Re: COVID 19 TESTING SITE
5200 San Mateo Blvd NE
Traffic Circulation Layout
Engineer's Stamp 10-21-2020 (F18-D012A)

Traffic Circulation Layout

C101

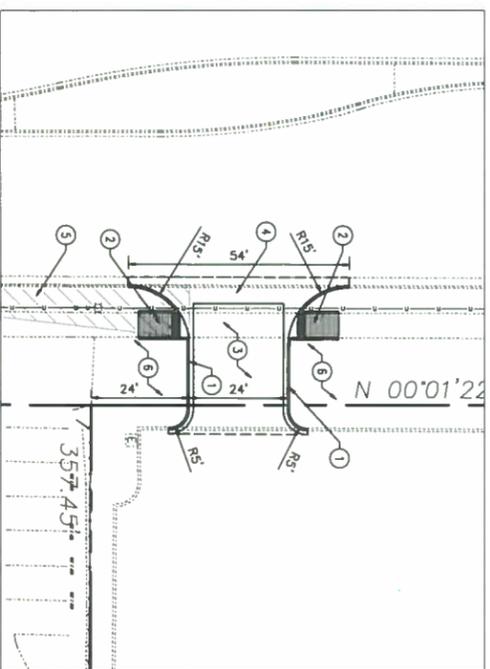
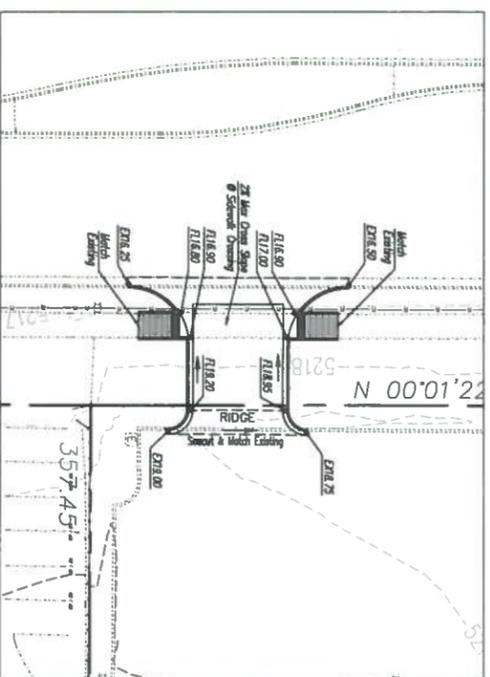
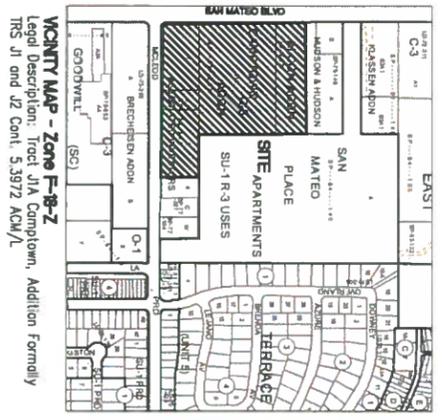
TRAFFIC CIRCULATION LAYOUT APPROVED
 Signed: *[Signature]*
 Date: 10/27/20

ALL WHEELCHAIR RAMPS LOCATED WITHIN THE PUBLIC RIGHT OF WAY MUST HAVE TRUNCATED DOMES.
